Intel[®] Pentium[®] III Xeon[™] Processor Specification Update

Release Date: November 2001

Order Number: 244460-031

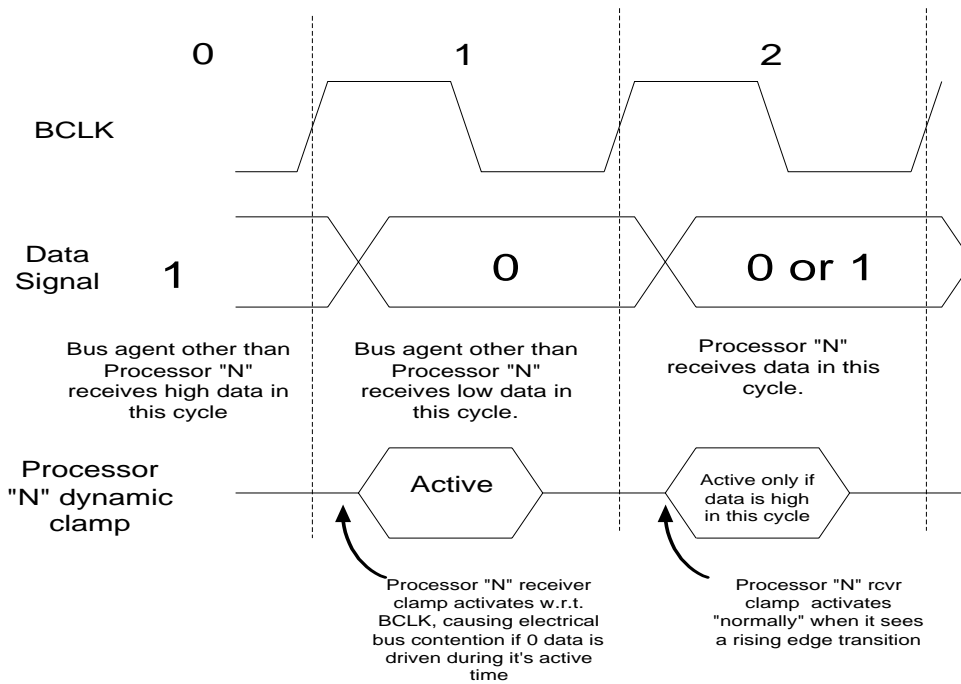
Workaround: The AGTL+ V_{REF} (input voltage reference) level will be raised from 1.0V to 1.1V (assuming a V_{TT} of 1.5V) on the processor cartridge substrate. This allows the dynamic clamp to activate at a trigger level approximately 100 mV higher than with the previous 1.0V V_{REF} setting. Due to the dependence upon system bus design, bus layout may be evaluated to determine the need for improvements in falling edge ringback levels. This may involve one or several of the following baseboard modifications:

1. Change termination resistor value to reduce multi-bit noise and/or improve V_{IL} noise margin.
2. Reduce multi-bit noise by improving ground return paths (additional high-frequency decoupling, improved AC plane referencing, etc.).
3. Raising or lowering the V_{TT} level (within the AC & DC tolerances specified in the processor EMTS) to improve V_{IL} noise margin and/or reduce the multi-bit noise due to dl/dt transients.

Stress tests using various data patterns and transactions should be run to identify the worst-case multi-bit noise conditions for this erratum.
